STAFF REPORT

REFERENCES: RM080103 (Subdivision and Land Use – Road Formation);
RM080182 (Land Use – Dwelling Setback);

SUBJECT: **ST LEGER GROUP LIMITED - REPORT EP08/12/02** - Report prepared for hearing of 8 December 2008

PLAN D
RM080103
Road Gradients 1:7

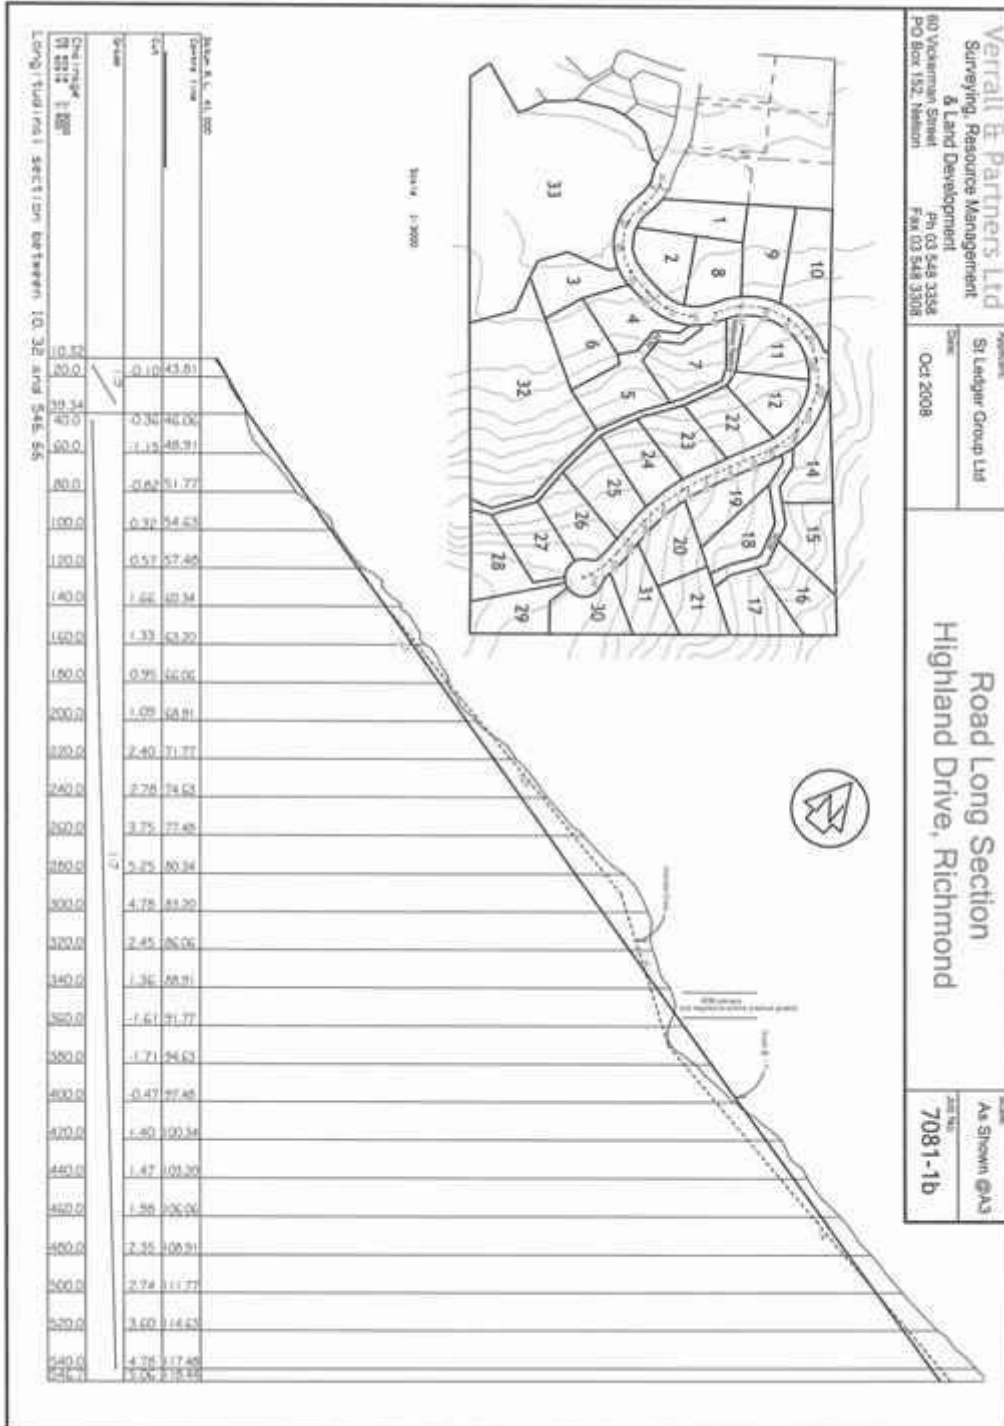
The proposed road will have a gradient steeper than 1:7, and up to 1:6, for a length 150 meters between chainage 140 and chainage 290, and also for another section with a length of 180 meters, between chainage 370 and chainage 540. Refer to **Plan D** and **Plan E**.

Mr Ley and Ms Muirson (Section 4.6) have suggested that it may be possible to achieve Council's desired 1:7 road gradient by realigning the position of the road. Mr Foley has indicated that some small reduction in grade may be possible. However there is doubt that the revised road location, and consequent 1:7 gradient is feasible from a geotechnical point of view.

PLAN E
RM080103
Road Gradients 1:6

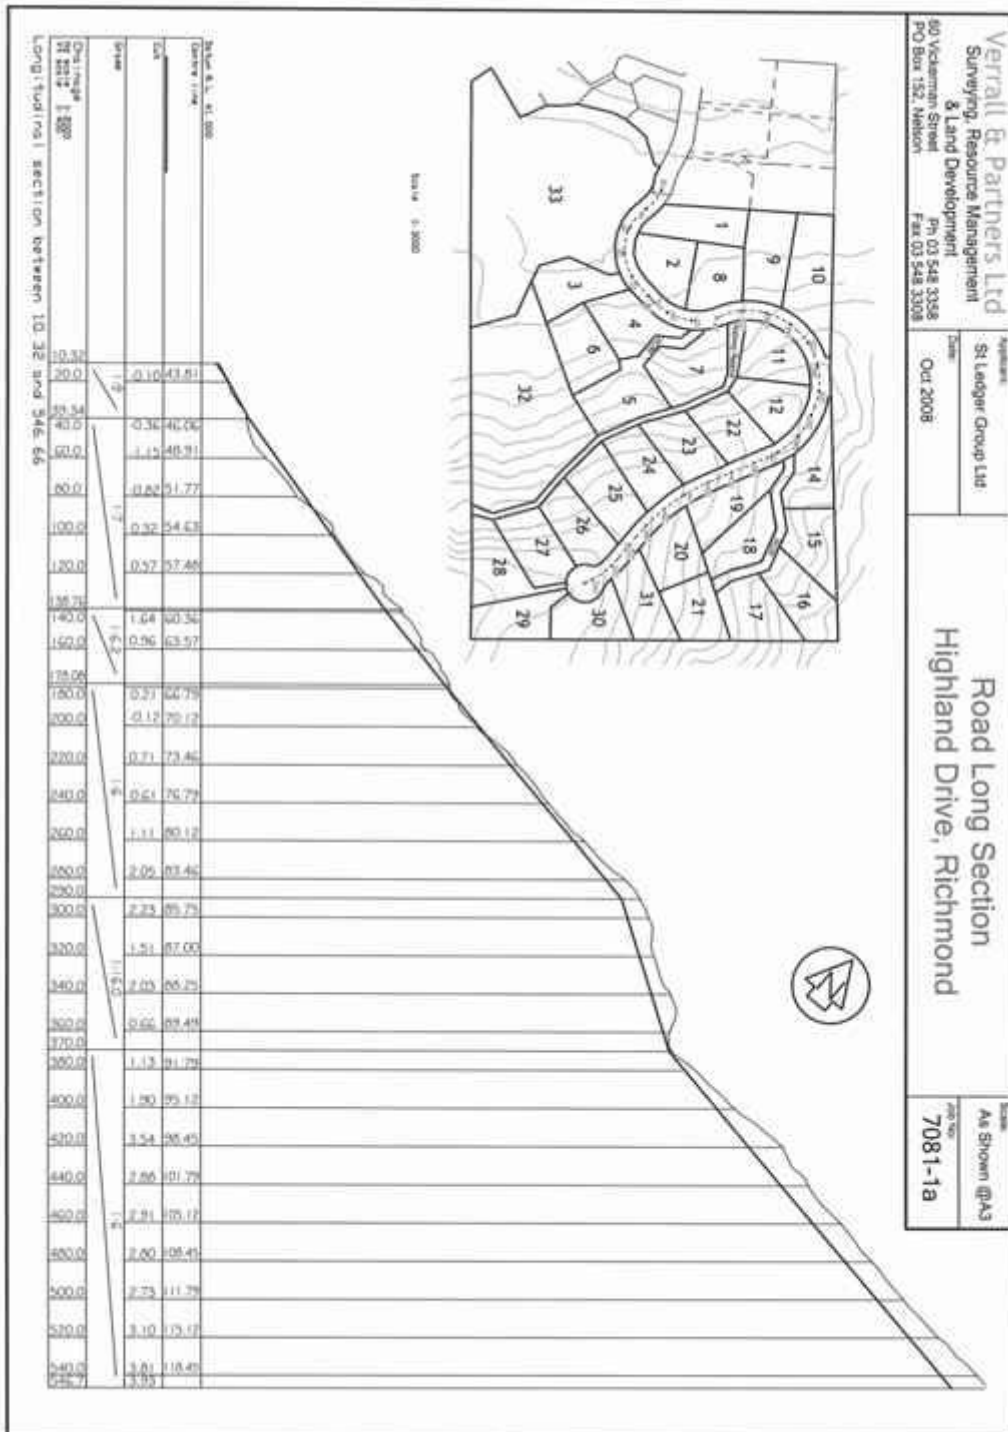
The applicant has sought consent to construct a road with a gradient of up to 1:6 along two sections of the proposed road to vest. The TRMP requires a road gradient of no steeper than 1:7 to comply with Figure 18.8A.

From a geotechnical point of view the road design must take into account the underlying ground conditions and the proposed 1:6 road design is considered feasible due to the smaller cuts and fills required. The applicant has provided **Plan D** and **Plan E** showing the approximate height of the cuts for a road constructed along the proposed alignment and Mr Foley has confirmed that there may be some scope to alter the road alignment but this was limited for geotechnical reasons.

- a) The maximum road gradients where they are steeper than 1:7 shall be as shown on **Plan E – RM080103.**
- b) The maximum lengths of those sections of road steeper than 1:7 shall be as shown on **Plan E – RM080103.**
- c) Written confirmation from the geotechnical engineer required by Condition 21(a) shall be provided to Council's Engineering Manager stating that taking into account the underlying ground conditions of the site that it is not feasible to construct the road at a lower gradient.
